STAFF RECOMMENDATION
205 South 10th Street
June 19, 2013

Application: New construction-infill

District: Lockeland Springs-East End Neighborhood Conservation Zoning Overlay

Description of Project: Applicant proposes to construct a multi-use development on a vacant lot at the corner of South 10th and Russell Streets.

A1 EXT. ELEVATION @ PEDESTRIAN COURT (WEST)
 1/16" = 1'-0"

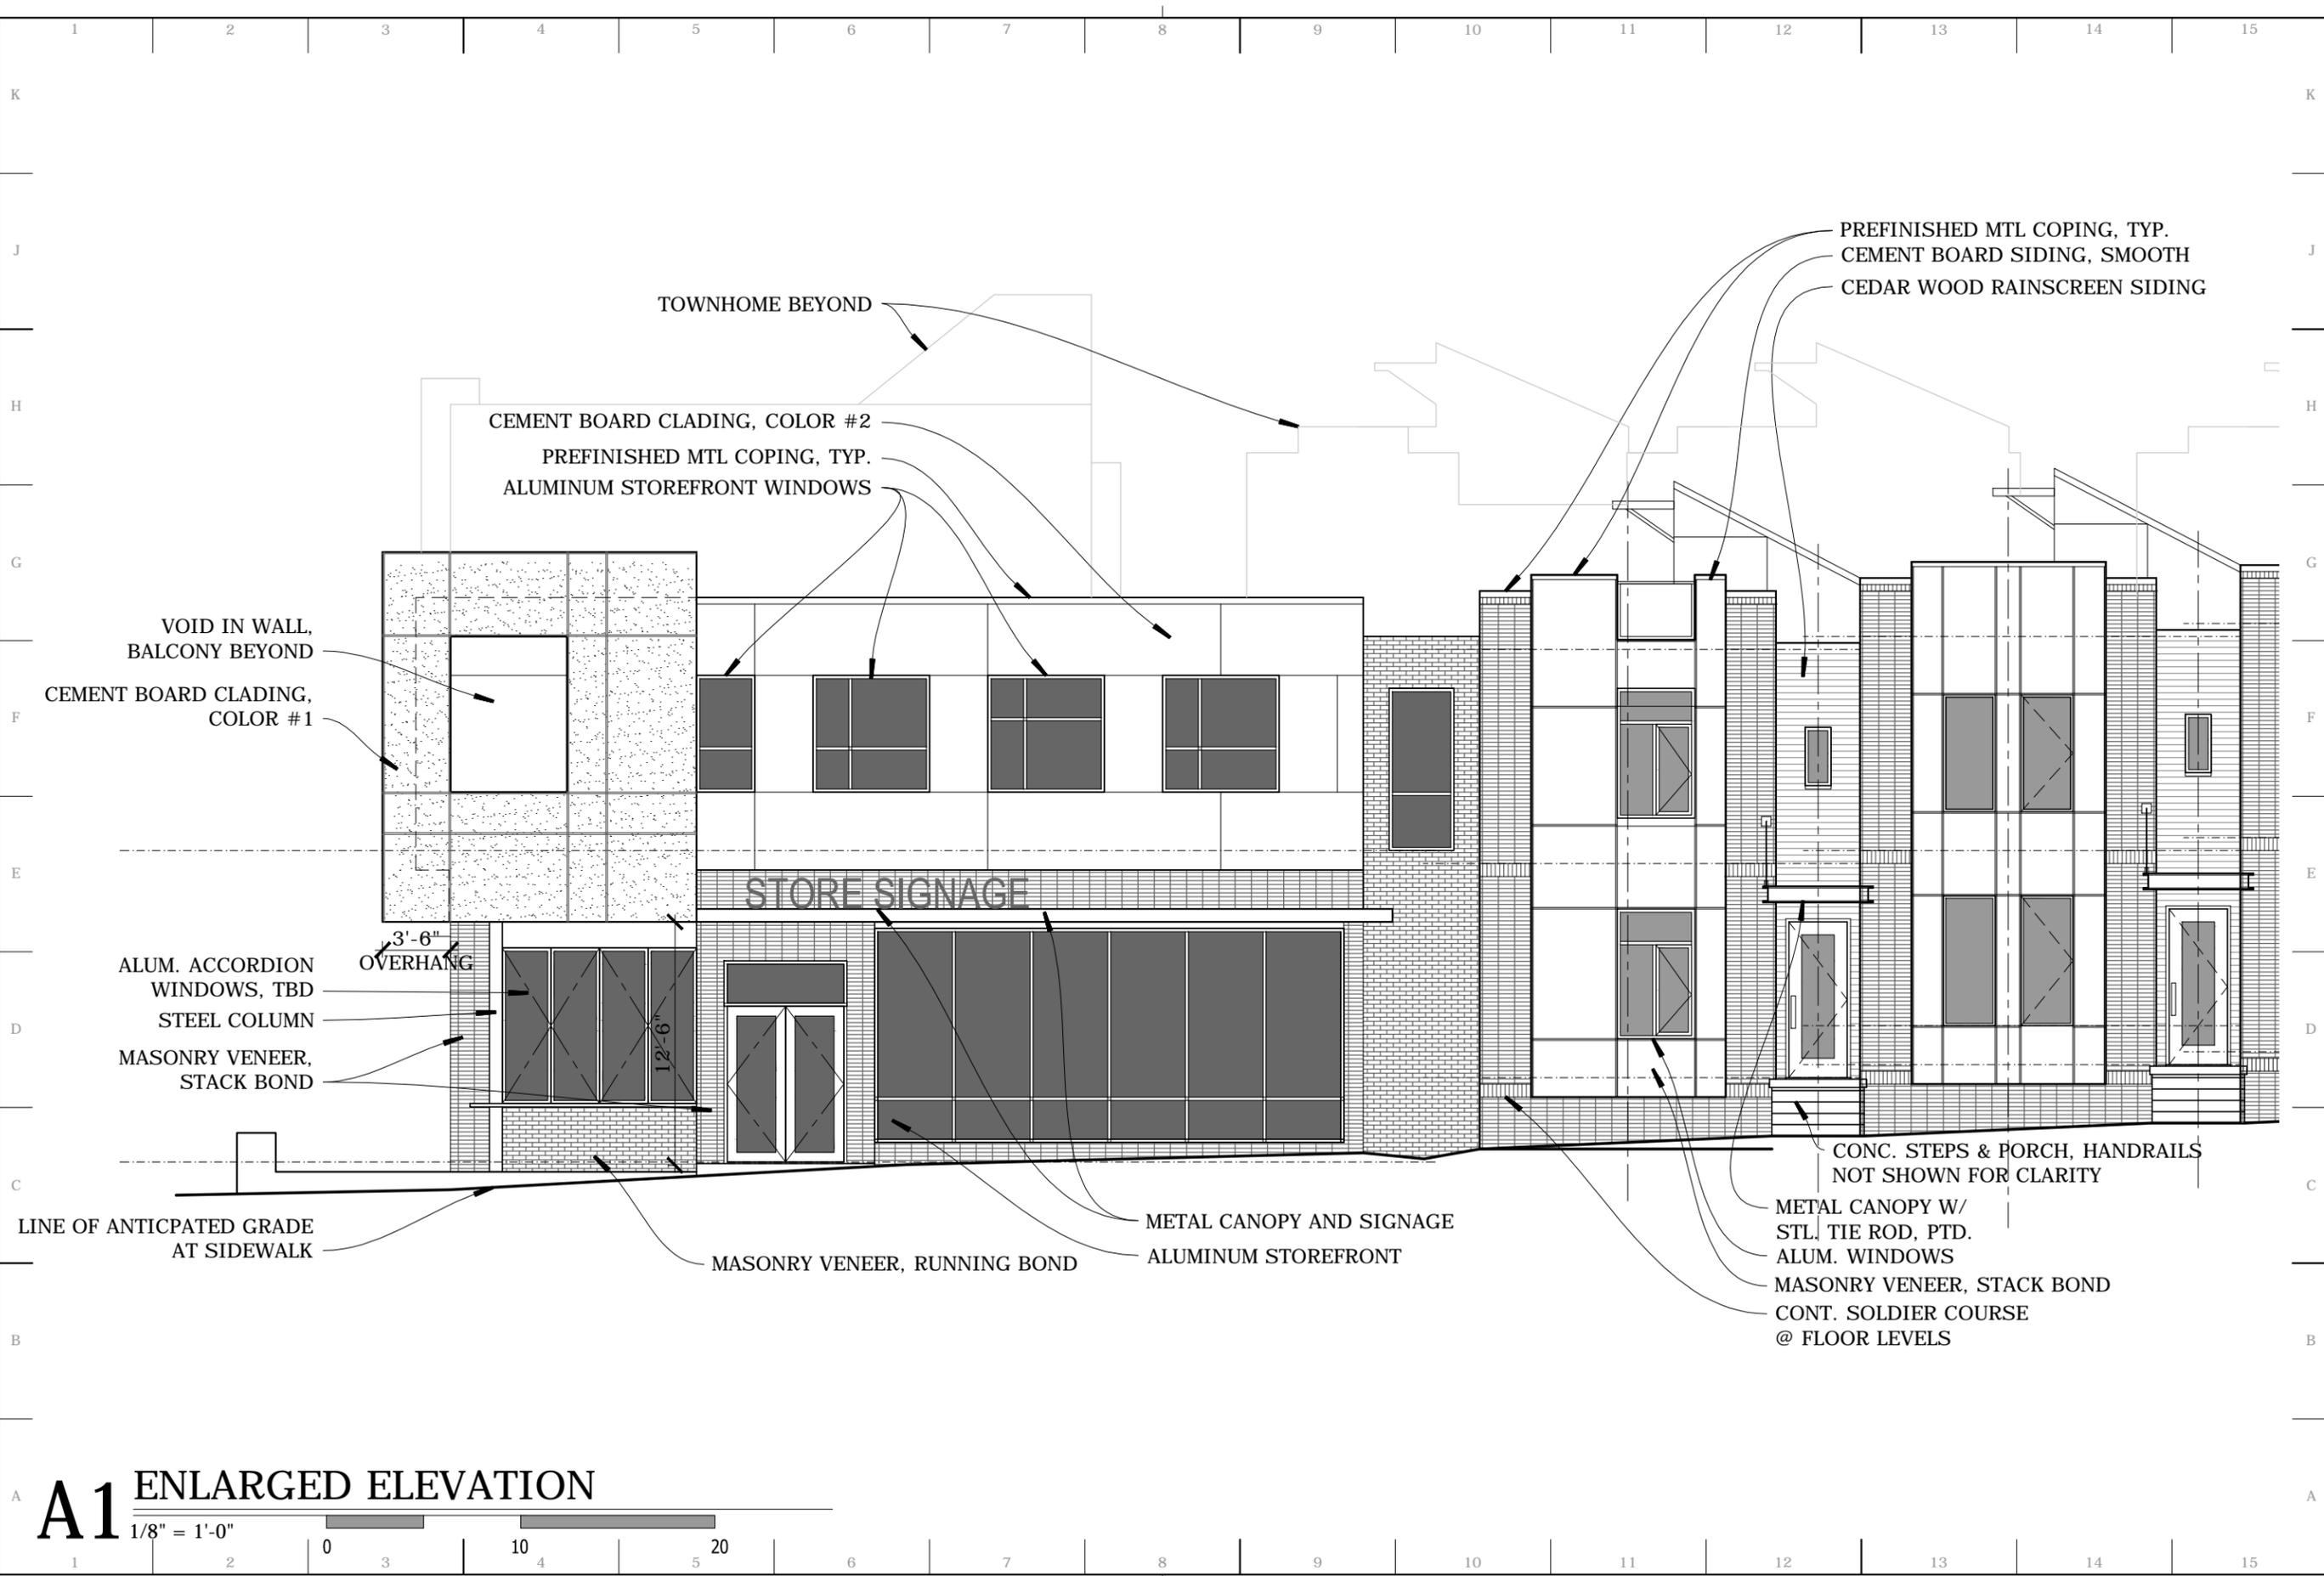
Relationship of Materials, Textures, Details, and Material Colors: The cladding includes masonry veneer running and stack bonds, cement board panels, and cedar wood rain screen siding. The rain screen has only been approved as an accent material by the Commission, so far, and will be minimally used on this building as well. The windows will be aluminum and the material for the doors was not indicated. Details and trim include concrete, steel columns, metal copings and canopies. All materials have been approved by the Commission in the past; however, additional information about their details, dimensions and color are needed. Staff recommends obtaining final approval of windows; doors; masonry color, dimensions and texture; the cement fiber connections, walkway materials and the lap siding reveal.

Recommendation: Staff recommends approval with the condition that the applicant obtain administrative approval of materials: windows; doors; masonry color, dimensions and texture; cement fiber connections, walkway materials and the lap siding reveal. With this condition the project meets the design guidelines for new construction.

F1 Russell Street FACING ELEVATION (North)
 1/16" = 1'-0"
 0 20 30

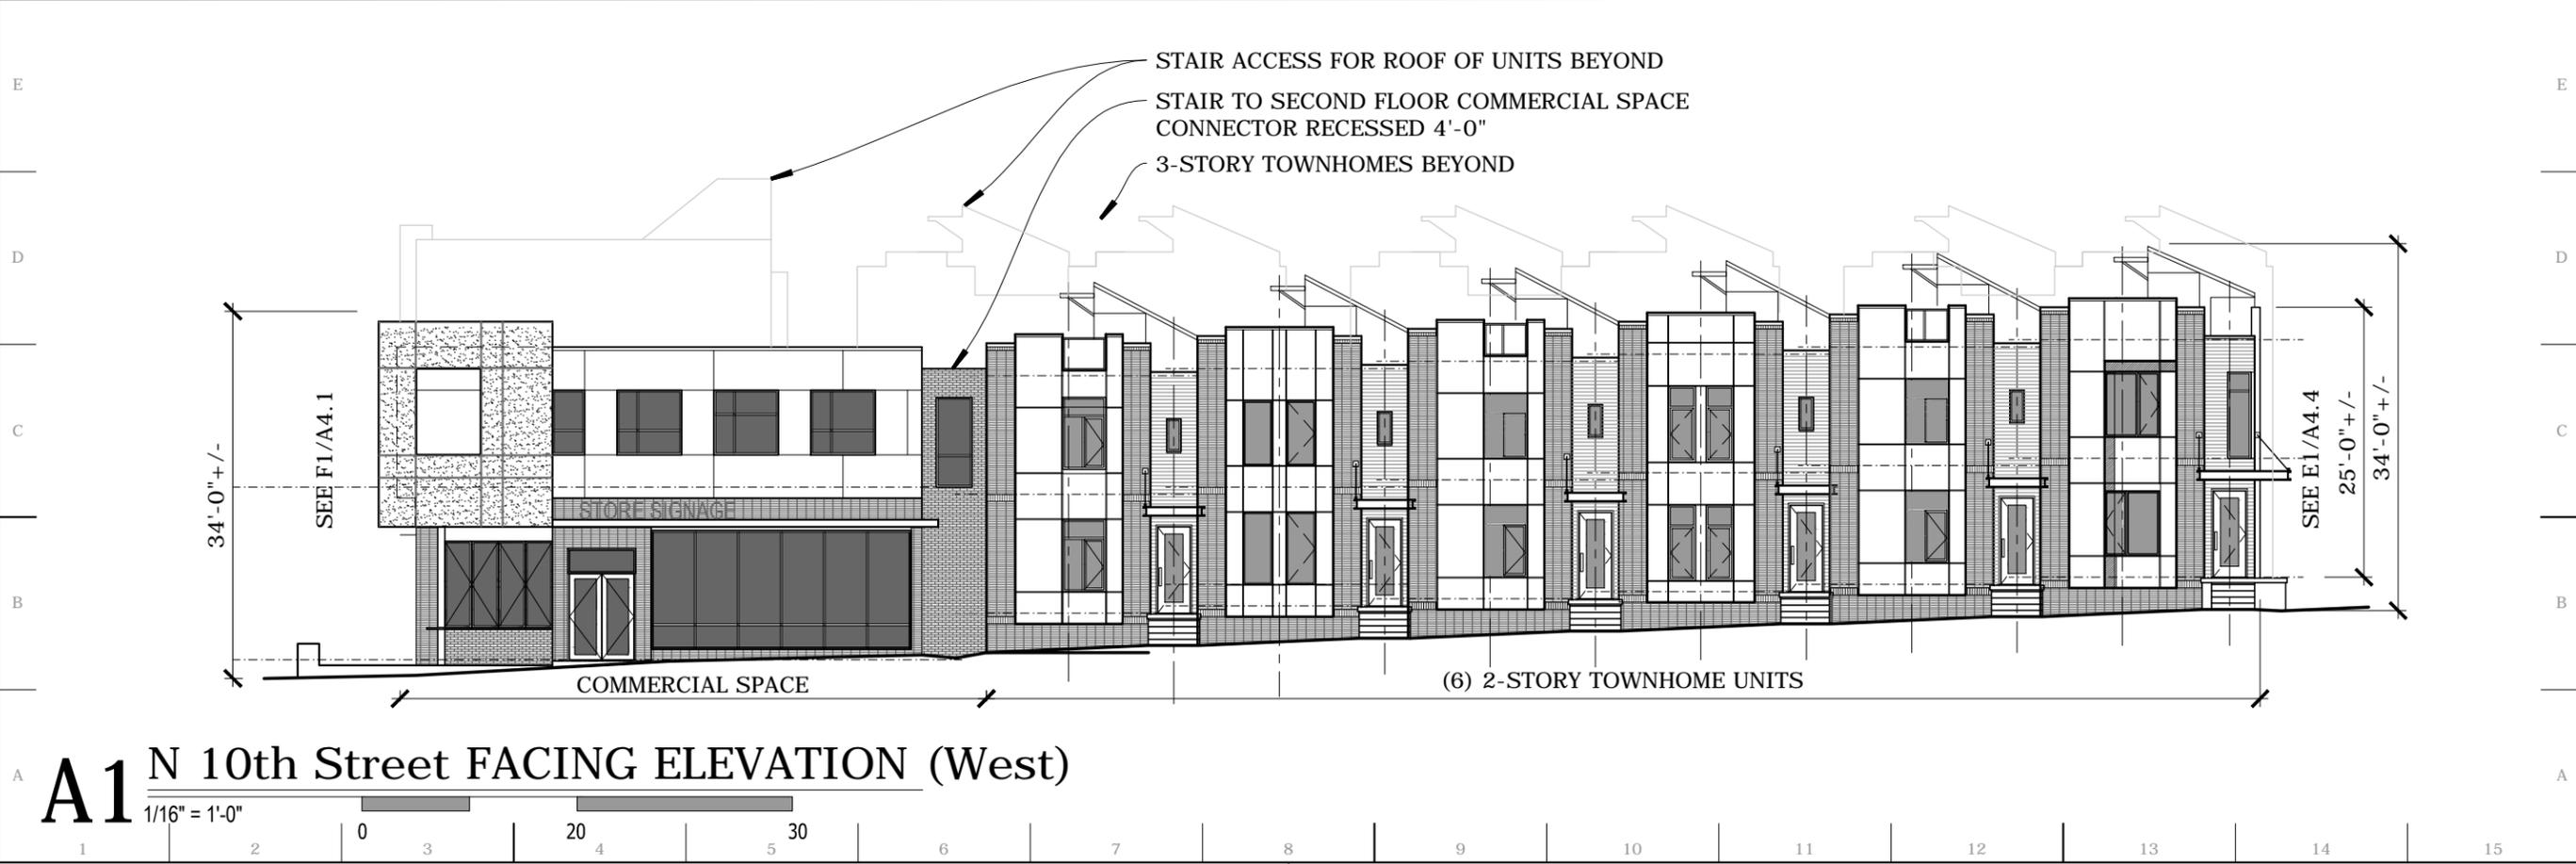
Orientation: The pedestrian orientation of the project is toward S 10th and Russell Streets, as seen historically. The interior units also have an orientation towards the streets with a walkway leading back from Russell Street. Vehicular access is fully off the alley. The project meets section II.B.6 and II.B.9.

A1 N 10th Street FACING ELEVATION (West)
 1/16" = 1'-0"
 0 20 30

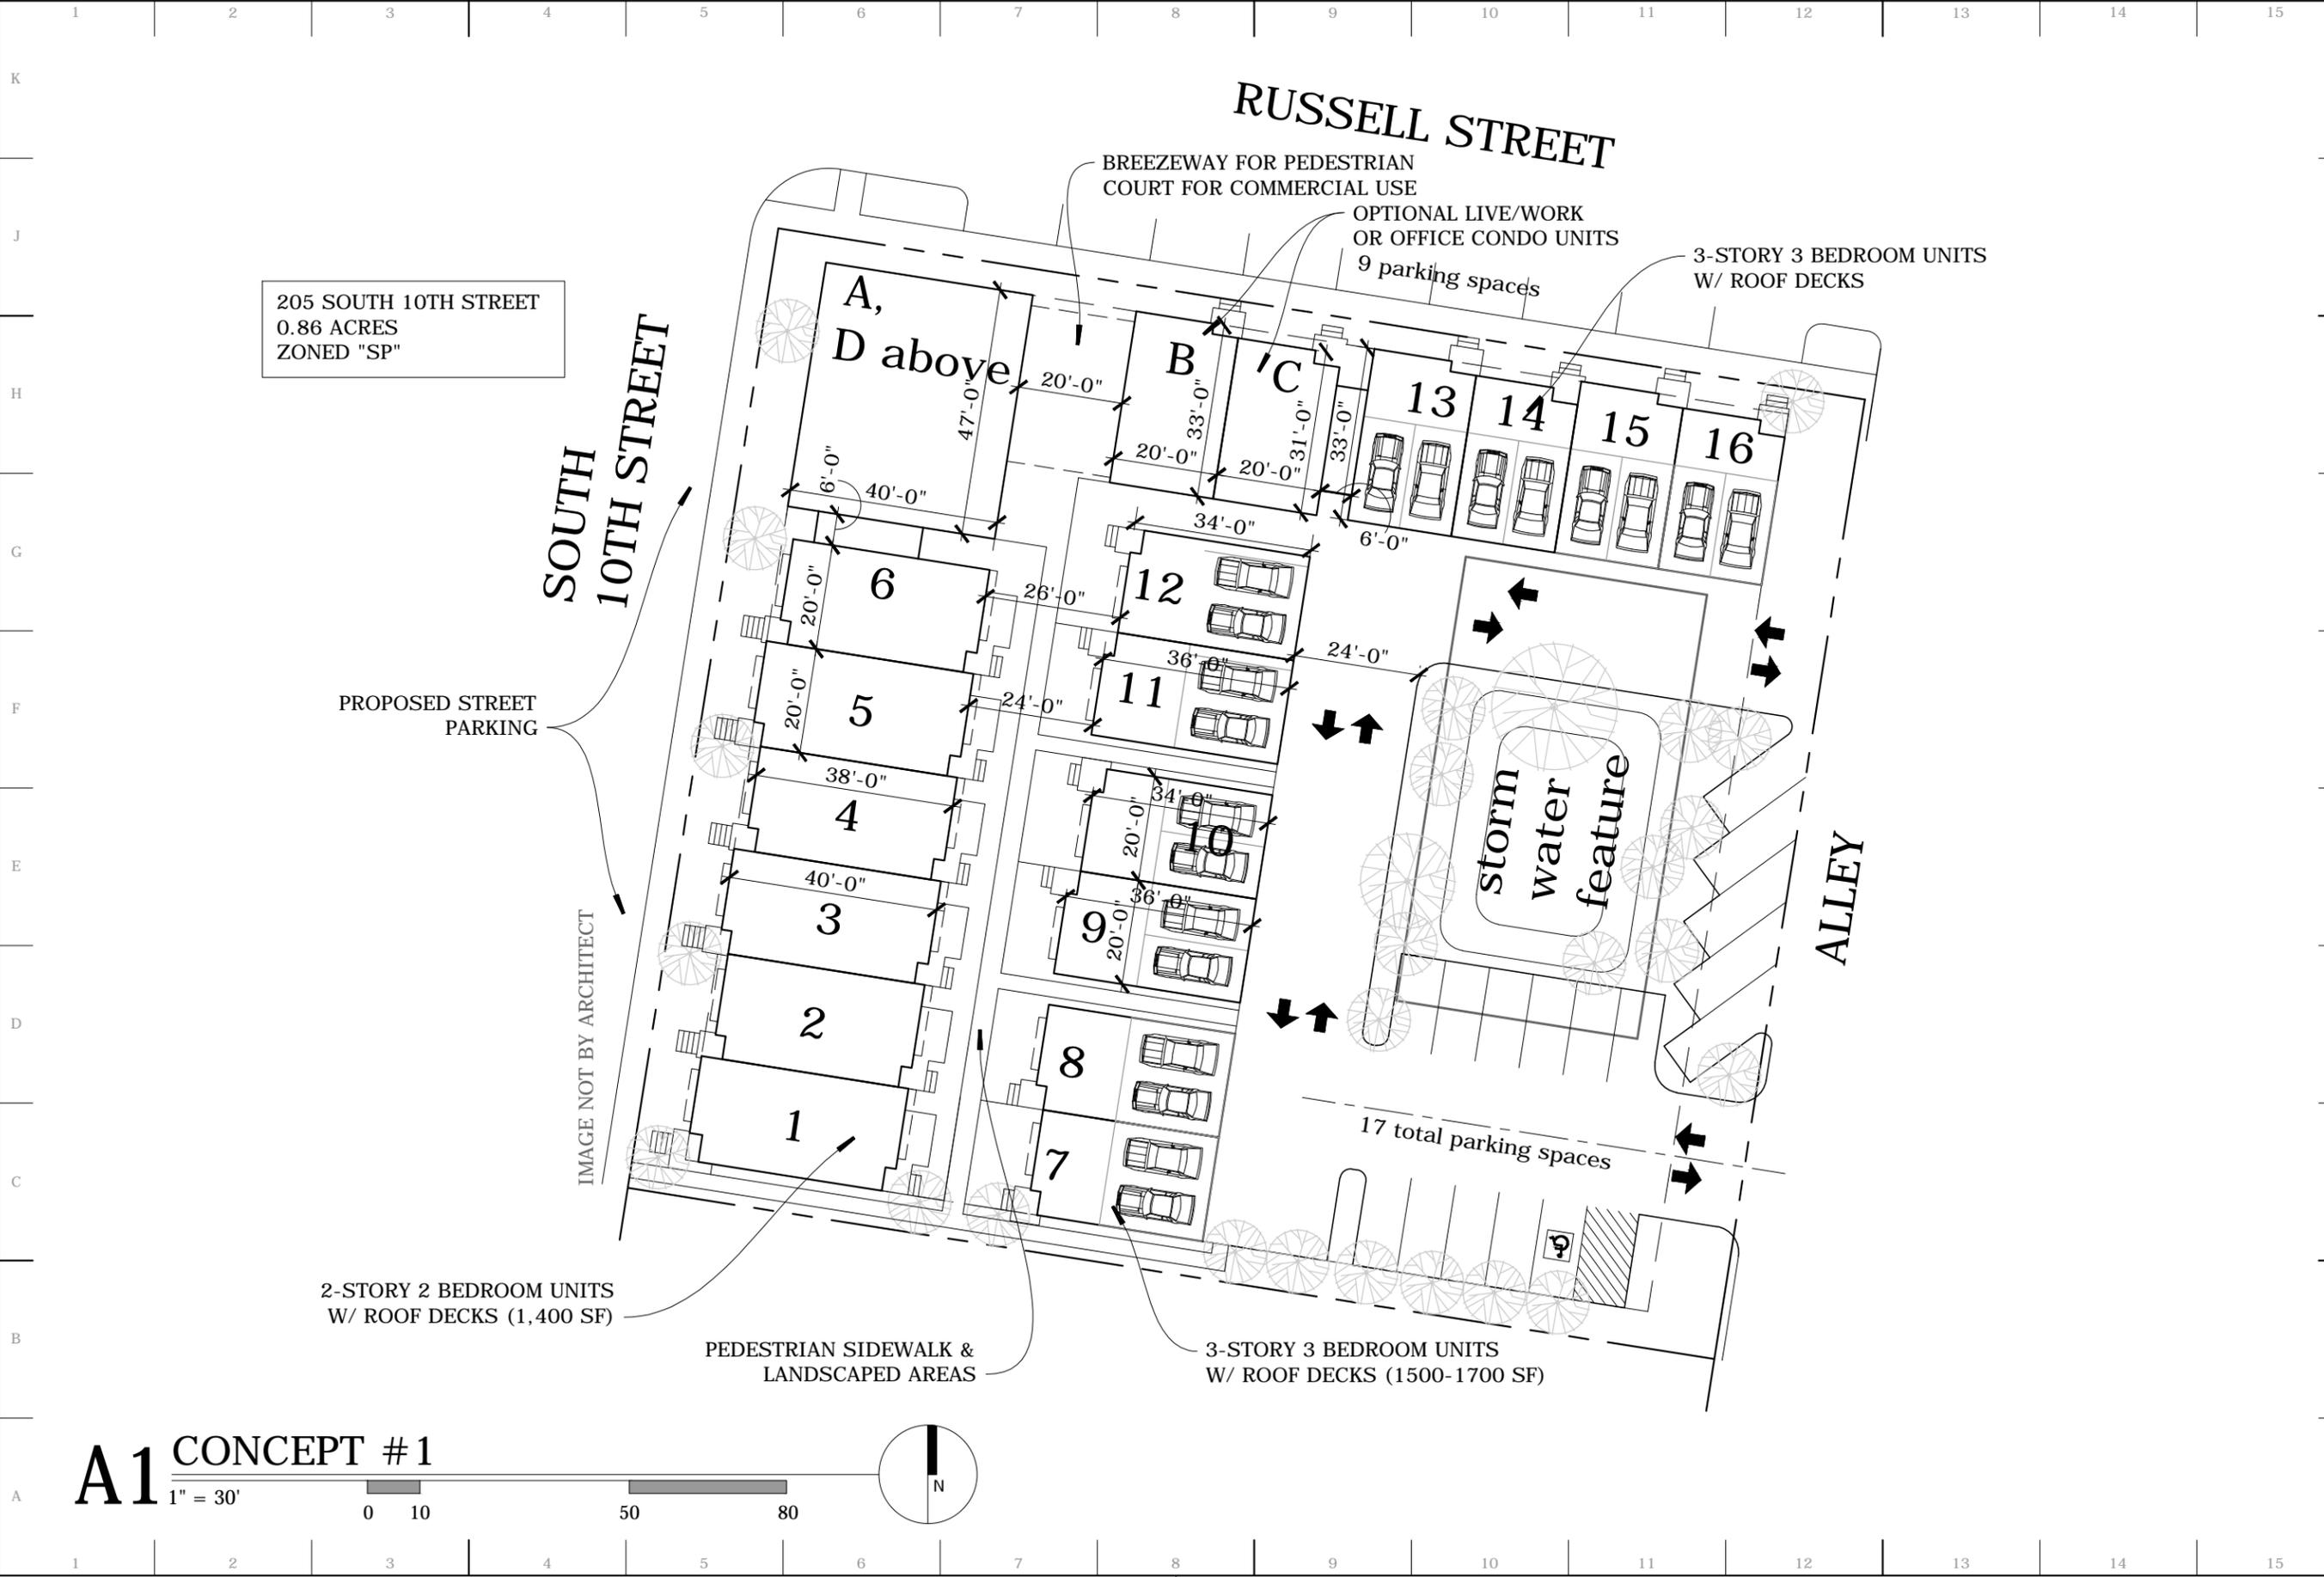
Setback and Rhythm of Spacing: The approved SP included a curb cut on S 10th Street, which is no longer part of the project, making the development more appropriate for the district. The original SP did not include the pedestrian connection from Russell Street to the interior of the project, which is another improvement over the original SP. The currently proposed setbacks vary between seven and twelve feet (7'-12'), not counting stoops and steps, which is similar to the varied setbacks approved in the SP. The project meets the setback requirements and general arrangement of the approved SP.
